Labrador, standing: seam layout v2.1

PROPOSAL FOR APPROVAL

Medium size: 350 mm nose to tail base. Drawn on base shape v0.4. 03 Nov 2026. Not for cutting: please answer the questions and send them back.

Proposed layout v2.1: 22 pieces (legs built like Cuddle Clones and Dragonmoss)

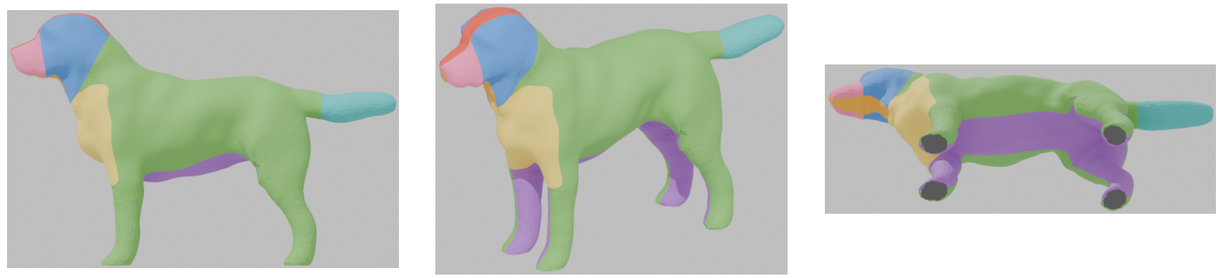
1. **Legs stay part of the body sides (outside) and the underbody (inside), as the competitors make them.**
   No ring seam at the elbow or knee, so the legs read as plush legs. Leg fur is trimmed short and brushed down.

2. **Chest in two halves with a centre seam, pile running down.**
   Like the competitors' short-coated dogs. In v1 the chest pile ran towards the tail (90 % off); now 6 %.

3. **Muzzle side pieces: seam from the stop, in front of the eye, to the corner of the mouth.**
   Both Cuddle Clones and Dragonmoss do this: sharper stop, fuller cheeks, a clean line for the short muzzle fur and the eye.

4. **Underbody in two halves with one centre seam underneath (v1 had four belly pieces).**
   Every piece stays within 9 % stretch when flattened (paw pads and tail apart).

5. **Darts instead of easing where a seam still needs more than about 3 mm of easing in 40 mm.**
   Positions come with the v2.1 pattern.
6. **Ears: a small pleat at the base so the ear turns forward and frames the face.**

7. **Unchanged: head gusset, chin gusset, centre-back seam, two-piece tail, paw pads.**

1. Legs as part of the body sides and underbody, like the competitors: OK?
   ☐ Yes ☐ No Comments: _____
2. Chest in two halves with a centre seam, pile running down: OK?
   ☐ Yes ☐ No Comments: _____
3. Head: A) muzzle side pieces as shown, or B) keep the v1 side head with a dart at the stop?
   ☐ A ☐ B Comments: _____
4. Darts instead of easing: OK? What is the most easing you are happy with in 40 mm of seam?
   ☐ Yes ☐ No Comments: _____
5. Paw pads come out about 26 mm across at medium. Separate pads (short pile or suede?), or close the leg end with a dart?
   ☐ Pads ☐ Dart Comments: _____
6. Ears: is a pleat at the base OK? (Lining in the same fur or a short pile? Please say in the comments.)
   ☐ Yes ☐ No Comments: _____
7. Do you already make a realistic dog you are happy with? Photos of its pattern pieces would help us.
   ☐ Yes ☐ No Comments: _____

What the finished plush should look like, with the v2.1 seams drawn in (on the plush they sit under the fur)

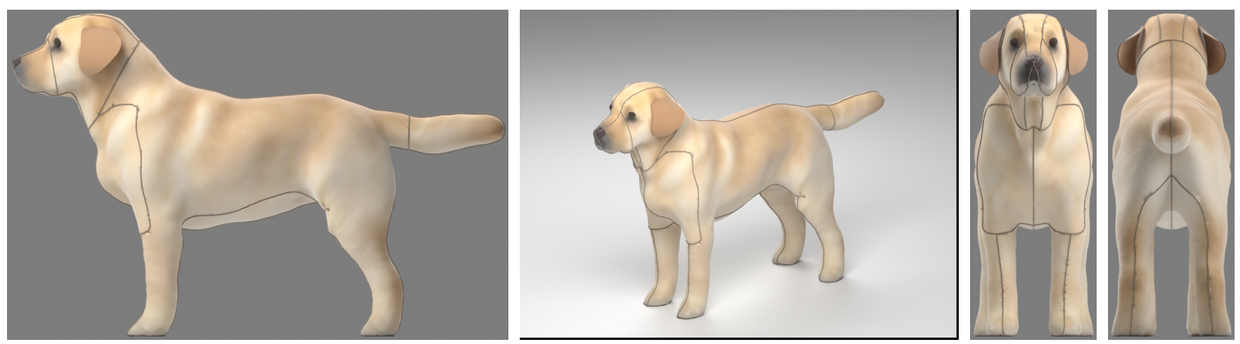
Fur direction check

Share of each area where the pile, once sewn, points more than 30 degrees away from a Labrador's coat direction. Legs and underside follow the competitor-style compromise; everything seen from the front and sides is close.

Area	v1 now	v2.1
Head	3 %	6 %
Body sides	9 %	8 %
Chest and shoulder fronts	**90 %**	6 %
Legs	**61 %**	**66 %**
Belly and inner thighs (underneath)	**42 %**	**83 %**
Tail	9 %	6 %

Colour guide on every piece (cutting orientation, pile down)

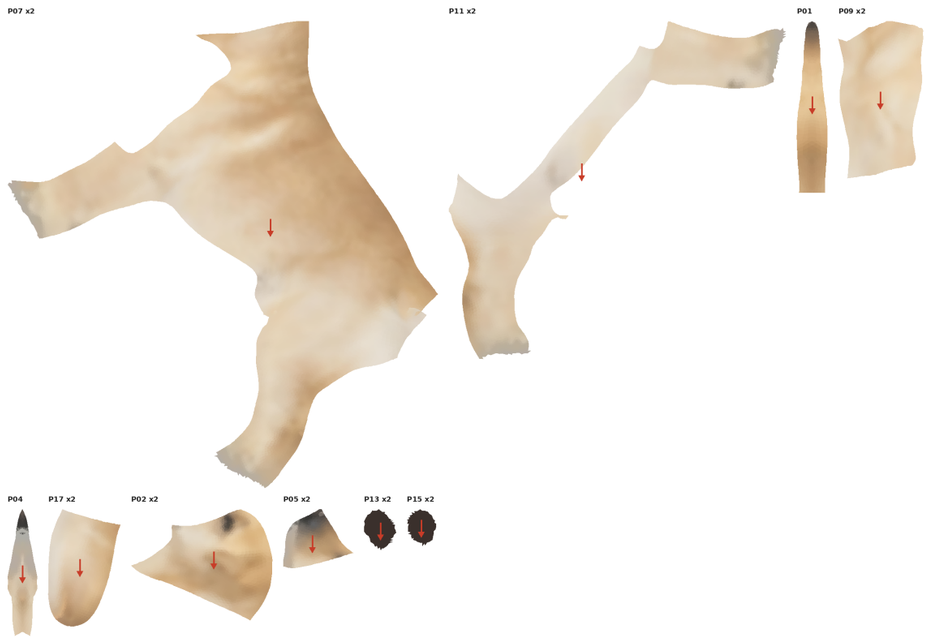
Colour and markings, read from the customer's photos

The coat colours were transferred from the photo-textured 3D model onto the plush shape. The white stock fur is airbrushed or dyed to match. A yellow Labrador's shading is darker on the ears, back and head and lighter underneath, as the breed standard describes.

Markings rule: markings and shading are airbrushed on the white stock fur from the colour guide; where a customers dog has a crisp marking edge (white bib, blaze, socks) the nearest seam is moved onto that edge so the colour change hides it.

Baked-in ground shadow on the paws and belly in the 3D model has been lifted, so the feet are coat-coloured.

10. Can you airbrush or dye the white fur to these four tones and the shading on the colour guide?
☐ Yes ☐ No Comments: _____

11. When a dog has a crisp marking (white bib, blaze, socks), is it OK to move the nearest seam onto the marking edge?
☐ Yes ☐ No Comments: _____

Fur trim zones

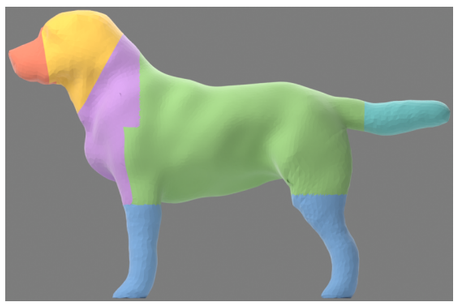
Stock fur: white acrylic pile on knitted polyester backing, straight and dense (not silky), pile at least 12 mm so the longest zone can be trimmed to length. Breed standard: coat short, straight and very dense, giving a fairly hard feeling to the hand; soft silky coats ... not typical.

muzzle	**4 mm**	shortest, velvety, like the competitors' short-pile muzzles
head and ears	**5 mm**	short and smooth; ears both sides
legs	**6 mm**	short, brushed downwards
body	**8 mm**	standard coat; brushed back and down
neck and chest	**10 mm**	slightly fuller at the neck and chest
tail	**8 mm**	thick all round, no feathering (otter tail)

Blend each zone into the next over about 10 mm. Lengths are starting values for the first sample.

8. Can you source a white, straight, dense (not silky) acrylic pile of at least 12 mm? Which pile lengths do you stock?
☐ Yes ☐ No Comments: _____

9. Can you trim to these zone lengths (4 to 10 mm)? Which clipper guards do you use?
☐ Yes ☐ No Comments: _____
